RE: *Industrial Wastewater Closure Module for Liquid Waste Tank 16H H-Area, Savannah River Site, Revision 0, February 2015*  
Savannah River Site  
Aiken County

### Responses to Comments Received During the Public Notice Period for INDUSTRIAL WASTEWATER CLOSURE MODULE FOR LIQUID WASTE TANK 16H H-AREA TANK FARM, SAVANNAH RIVER SITE, REV. 0

**NRC Staff Comments on: “Industrial Wastewater Closure Module for the  
Liquid Waste Tank 16 H-Area Tank Farm, Savannah River Site,”  
SRR-CWDA-2013-00091, Revision 0, February 2015**

Figure 3.1 12: Summary of Tank 16H Waste Removal During the CSR Campaigns

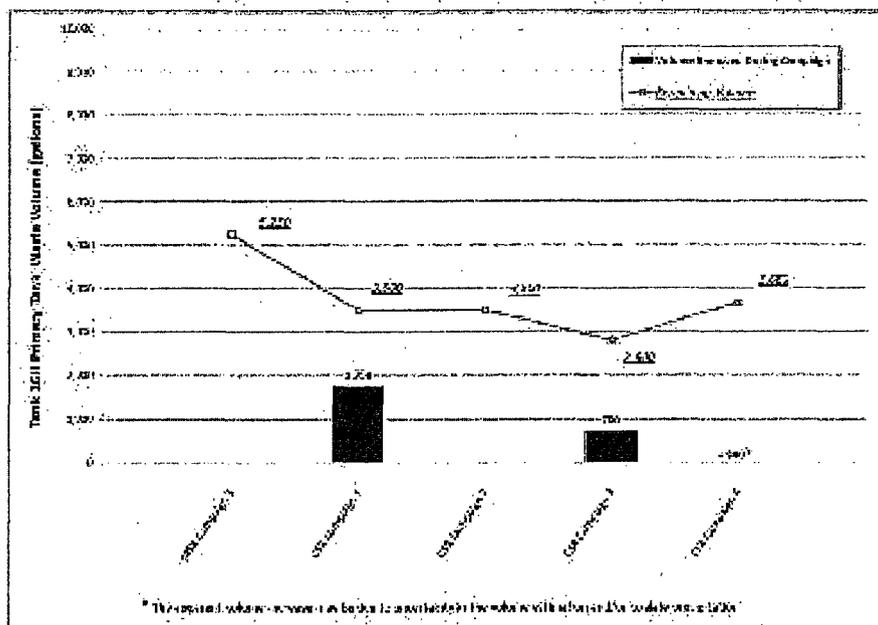
2.2 The Closure Module summarizes the cleaning campaigns to remove residual sludge from Tank 16H. The volume estimates provided suggest that the four chemical cleaning campaigns were marginally effective at removing waste from the tanks in comparison to the final rinse. From page 38:

"The four CSR campaigns reduced the estimated residual heel volume in Tank 16H from approximately 5,250 gallons to approximately 3,680 gallons. [DPSP-80-17-23]"

Because of the uncertainty in volume estimates and the possible formation of oxalates leading to increases in volume, it is not clear that the volume estimates provided are a good indication of the effectiveness of oxalic acid (i.e., perhaps oxalic acid effectiveness is greater than the volume estimates suggest).

- o Does DOE have additional data to estimate the inventory before and after oxalic acid campaigns to provide a more informative evaluation of oxalic acid effectiveness (e.g., radionuclide concentration data before and after oxalic acid treatment)?

*Figure A13-1: Annulus Sample Locations and Image Locations*

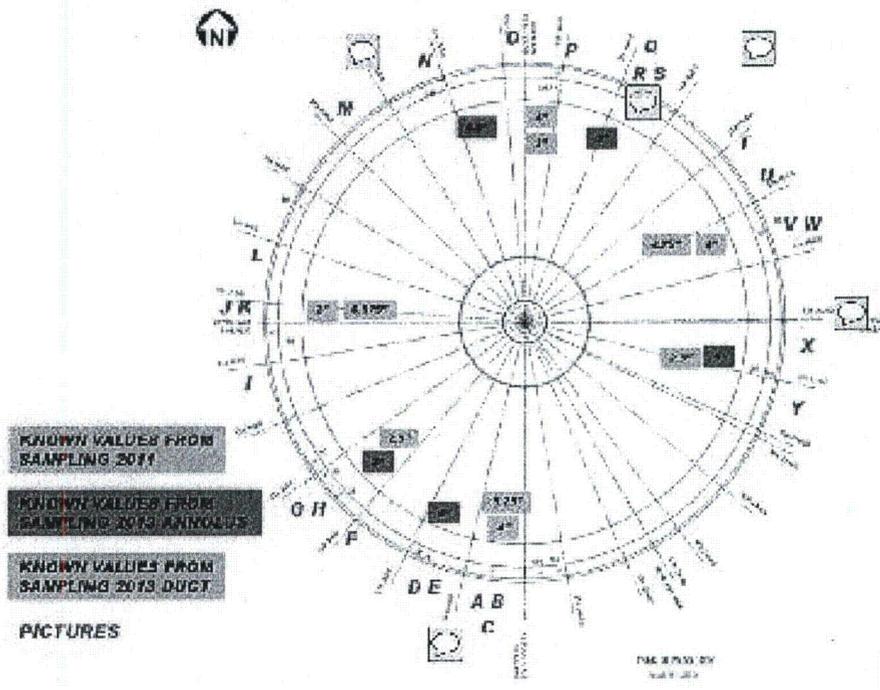
4.3 Figure 4.2-6 shows six samples were taken from inside the duct and five samples from outside the duct. The Closure Module on page 71 explains that:

The assignment of the 2011 samples into the three composite samples is described in Table 4.2-4. The depth measurements taken for volume estimation indicate that there is variability in the depth of the waste in the annulus as well as inside the duct. The Closure Module (on page 71 states:

- *Neither SRNL-STI-2011-00323 nor the LWTRSAPP, nor the Tank 16H Residual Sample Analysis Report (SRNL-STI-2014-00321, Revision 1) indicates the individual sample proportions used for the composite samples. Could DOE clarify which reference contains this information, including discussion of volume uncertainty and effect on inventory estimates? Considering that the total volume was revised from 3,300 gallons to 1,900 gallons, were the individual sample proportions for compositing derived from the depth information for the 3,300 gallon estimate or the new depth information for the revised 1,900 gallon estimate?*

ATTACHMENT 1 – WASTE LEVEL ESTIMATES

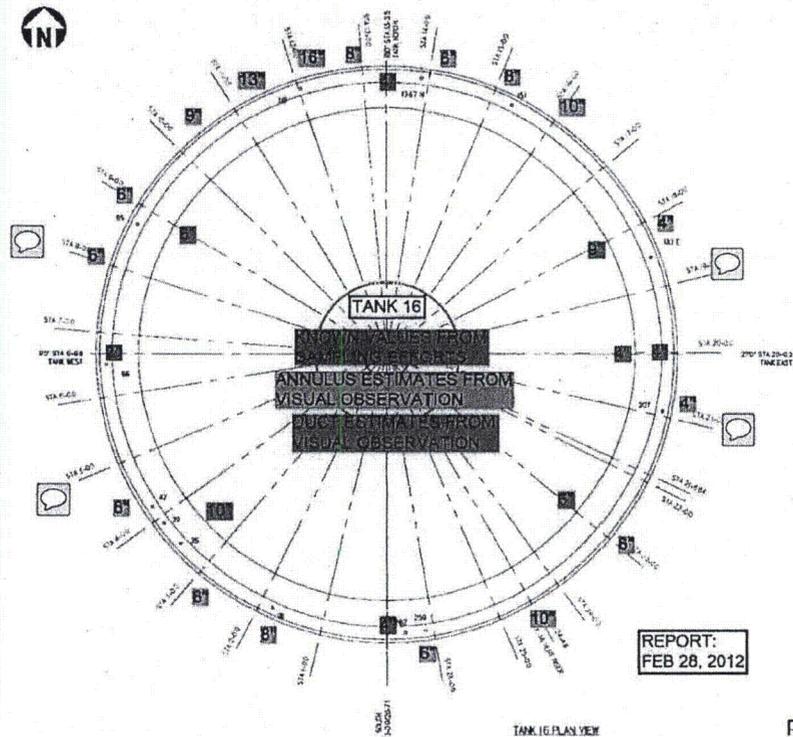
5.6 At Station 9+00 the depth estimate was reduced from six inches to one inch, and at approximately Station 25+00 from ten inches to four inches. The 2011 estimates were based on visual observation according to the Figure in Attachment 1 of SRR-LWE-2012-00039. There do not seem to be new photos or samples for these Stations in 2013 to help inform the reduction in these estimates. Instead, it appears that the reduction seems to be a result of interpolation between 2013 measured sample heights.
